December 18, 2012

**Re: Hardware change notice. Intel Motherboard DQ77MK.**

Figure 1. - Intel DQ77MK Motherboard

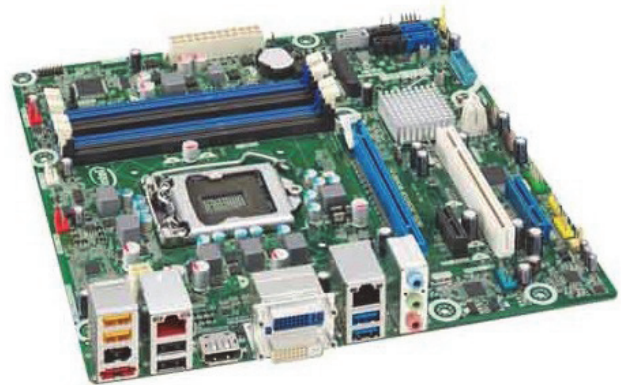
Due to our previous positive experience with Intel line of motherboards, we will continue using the Intel brand. Starting immediately, all Compact Wallmount DVR and NVR models will be switching to **Intel DQ77MK** motherboard model from the current *Intel DH55HC*.

The new motherboard model, **Intel DQ77MK**, meets all the requirements of our Compact Wallmount DVMS line. This motherboard features a total of 6 Serial ATA (SATA) inputs and a total of 10 USB 2.0 ports (4 external, 6 internal) and 4 USB 3.0 ports (2 external, 1 internal). *Intel DQ77MK* motherboard supports up to 32GB of RAM, one PCI slot, one PCIe x4, one PCIe x1, and one PCIe x16 v3.0 connectors; moreover, this motherboard features two built-in Gigabit Ethernet Controllers (RJ-45 LAN Connectors).
